Remarks

Applicant:	CHAUVIN	Examiner:	C. COHEN
Serial No.:	09/484,344	Group Art Unit:	3634
Filed:	JANUARY 18, 2000	Docket No.:	9320.95US01
Title:	MANUFACTURING PROCESS FOR AN AUTOMOBILE VEHICLE DOOR, AND THE CORRESPONDING DOOR

Fig. 1
PRIOR ART

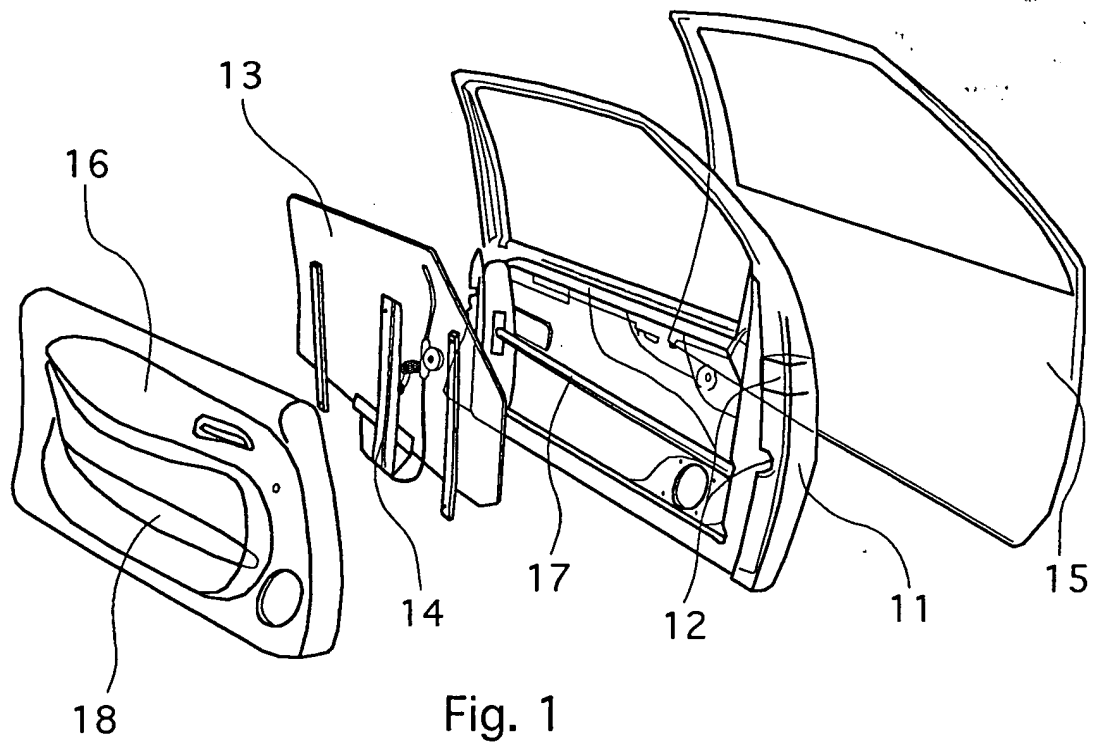
Figure 1 is objected to as not including a legend identifying it as prior art. Applicant respectfully traverses the objection. Applicants submit herewith an amended copy of Figure 1, including such a legend. Applicants believe the amendment overcomes the objection.

Fig. 2

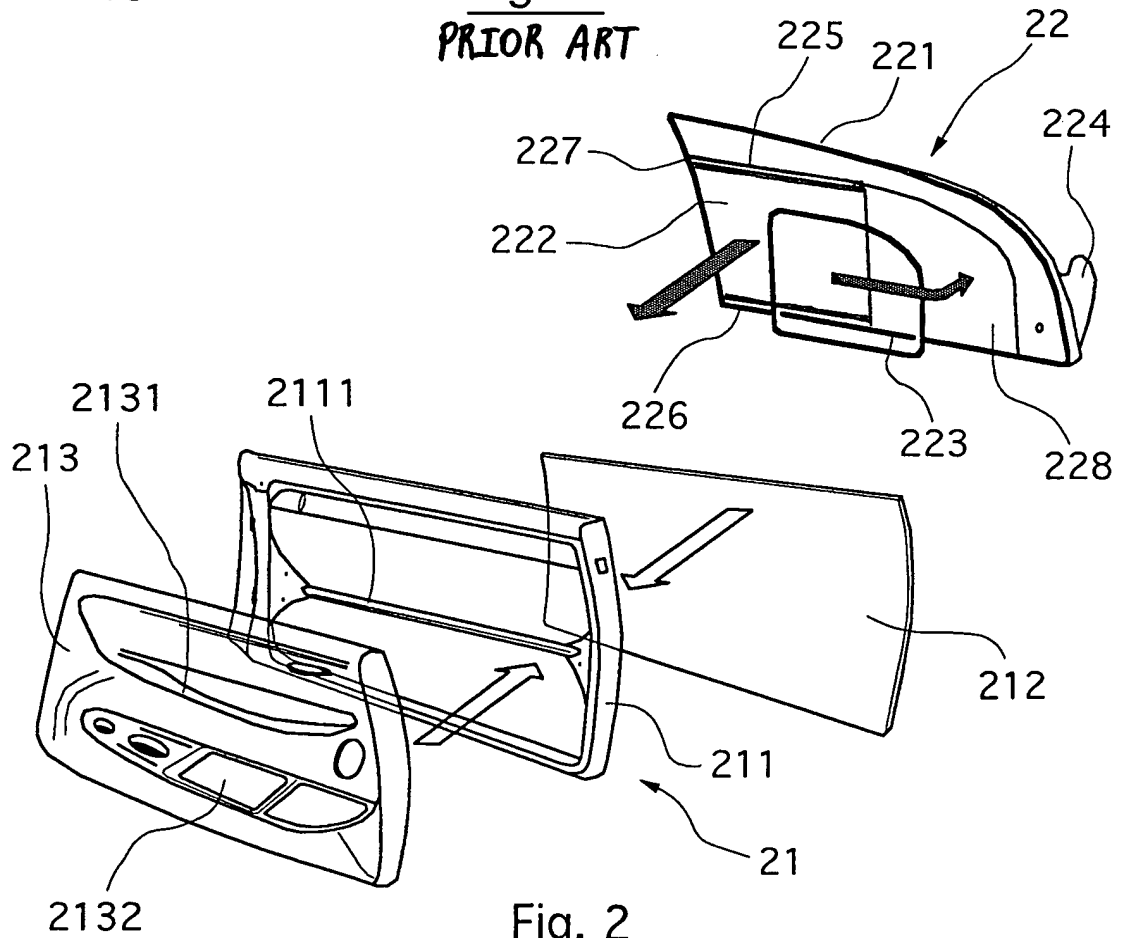
Thus, in response to the objection, Applicant respectfully submits that the fixed assembly 222 is fixed, and that the mobile panel 223 is movable, as noted above. The guide means 225 and 226 support the mobile panel 223, as disclosed for example at page 9, lines 17-18. The fixed assembly 222, being fixed, does not slide in guide means 225 and 226.

With regard to the illustration of the guide means 225 and 226, Applicant thanks the Examiner for his constructive criticism. Figure 2 is amended herein to distinguish the guide means 225 and 226 from the edges of the fixed assembly 222.
